**General Motors Corporation
Worldwide Facilities Group
Environmental & Regulatory Support
Remediation Team**

16 August 1996

Re: Linden Road Site
Flint Township
Genesee County, Michigan

General Motors (GM) has received review comments from the Michigan Department of Environmental Quality (MDEQ) by letter dated 19 July 1996, on the January 1996 Remedial Action Plan related to the Linden Road Site, Flint Township, Michigan. Subsequently, a meeting between the MDEQ, GM, and Roy F. Weston, Inc. (WESTON®) was held on 8 August 1996 in Flint, Michigan to discuss the MDEQ's comments in detail. Based on the 19 July 1996 MDEQ letter and the 8 August 1996 meeting discussions, the following responses to the MDEQ's comments were prepared by WESTON on behalf of GM.

FIGURE 1

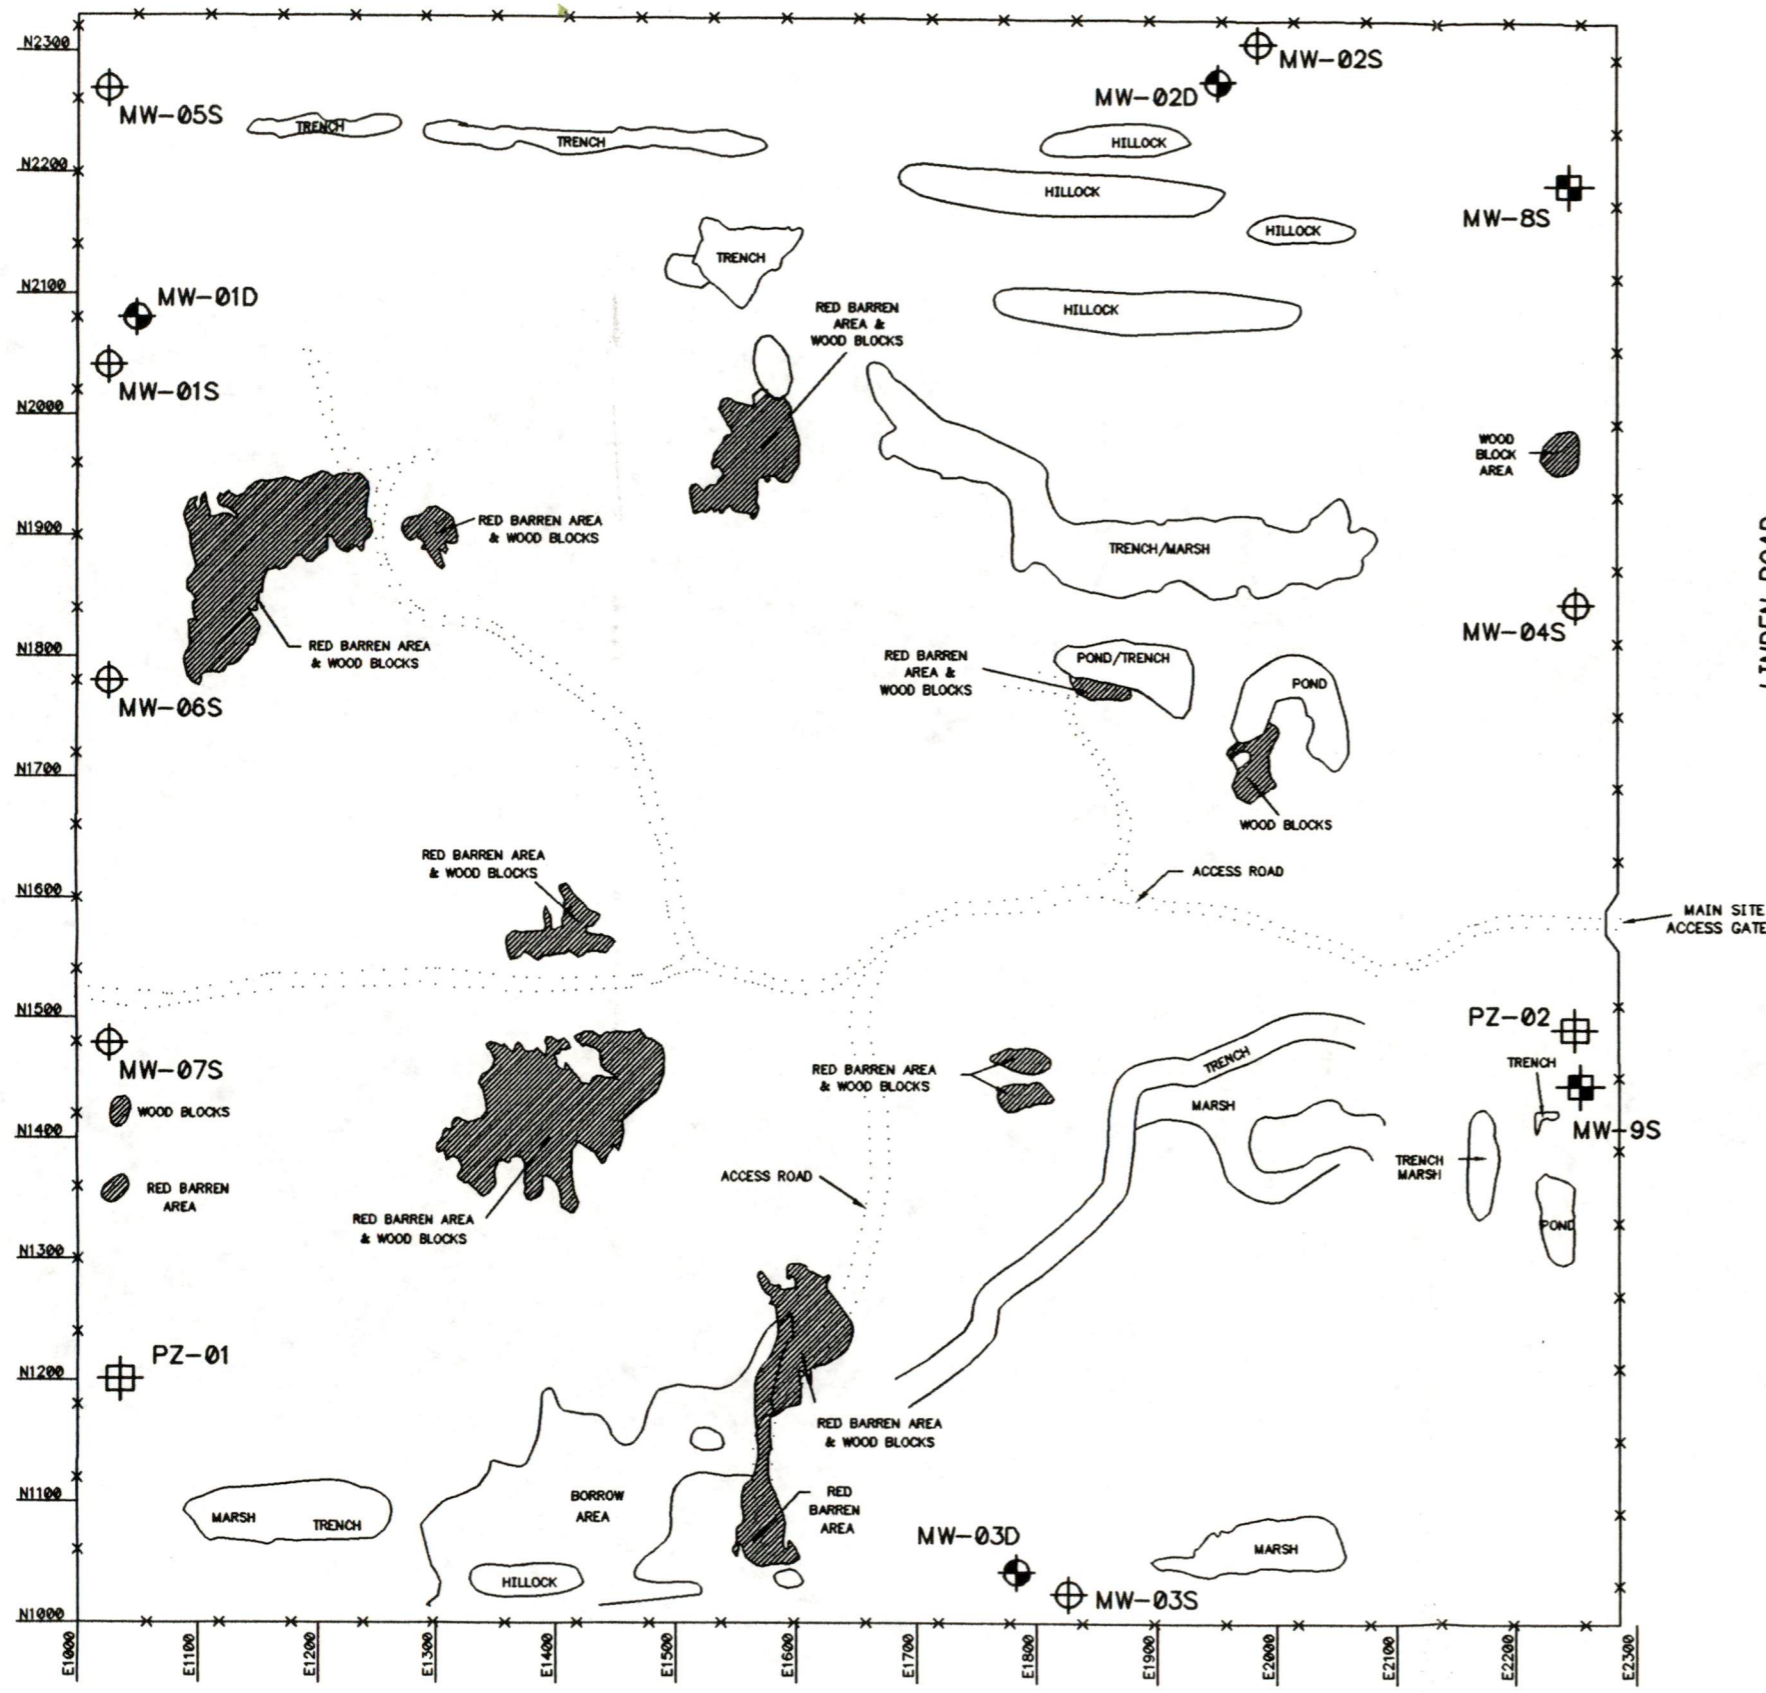
- a. *Further characterization of the groundwater is necessary both within the interior of the landfill and downgradient of the landfill. All groundwater sampling conducted to date has been along the perimeter of the landfill with no information regarding the groundwater quality within the landfill itself. A limited assessment of groundwater quality within the interior of the landfill is necessary to ascertain what cleanup objectives can be met (i.e., whether criteria can be satisfied at appropriate compliance points). The MDEQ recommends the installation of no less than five additional monitoring wells in the interior of the landfill to characterize groundwater quality. These wells may also be used in calculating groundwater flow direction and/or long-term monitoring of groundwater quality.*

In addition, there are an inadequate number of downgradient monitoring wells for the shallow aquifer. With the site being 40 acres in size, fill material randomly disposed of across the site, groundwater flow direction varying between the northeast and southeast, and the existing monitoring wells approximately 600 feet apart, additional wells should be installed to more adequately monitor groundwater quality moving off-site.

GM agrees that the installation of additional downgradient monitoring wells may be appropriate to adequately monitor the shallow water-bearing zone in the long term. GM proposes to install two shallow monitoring wells at the locations shown in Figure 1. The establishment of and justification for the detailed groundwater monitoring program would be documented within the Groundwater Monitoring Plan. Upon the installation of additional monitoring wells along the downgradient site boundary, as stated above, an additional round of water level measurements will be recorded and a groundwater potentiometric surface map indicating groundwater flow direction will be prepared and submitted to the MDEQ. An Operations and Maintenance (O&M) Plan would be submitted concurrently with the Final Design Submittal, as indicated in Subsection 5.5 of the RAP.

FIGURE 2

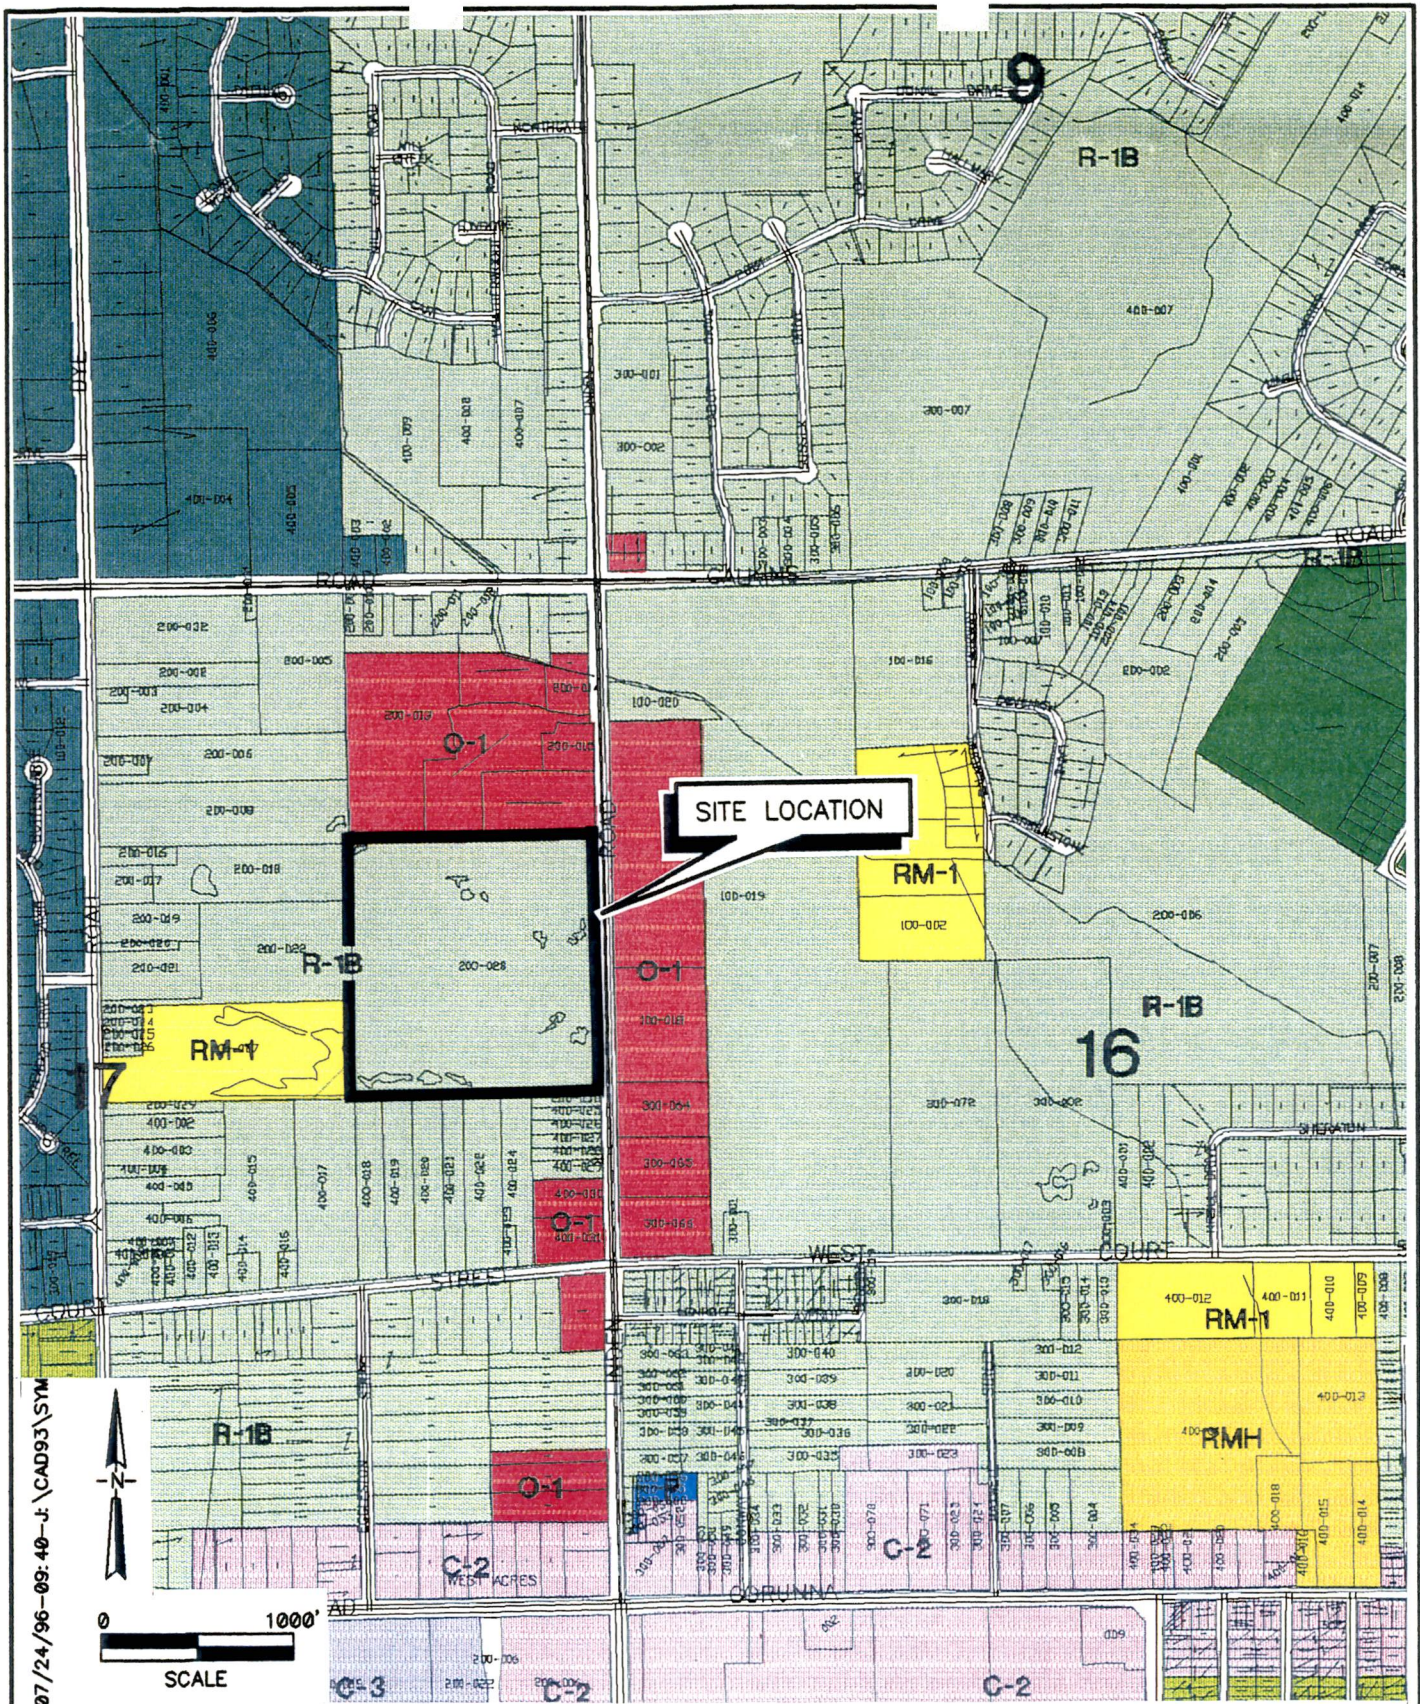
Comment 3: *Documentation must be submitted indicating that the current zoning of the property is consistent with the categorical criteria being proposed or that the governing zoning authority intends to change the zoning designation, if generic commercial or industrial criteria are proposed for closure.*

Response: As shown in the attached zoning map (Figure 2), the Linden Road property is designated as R1B (residential and recreational).
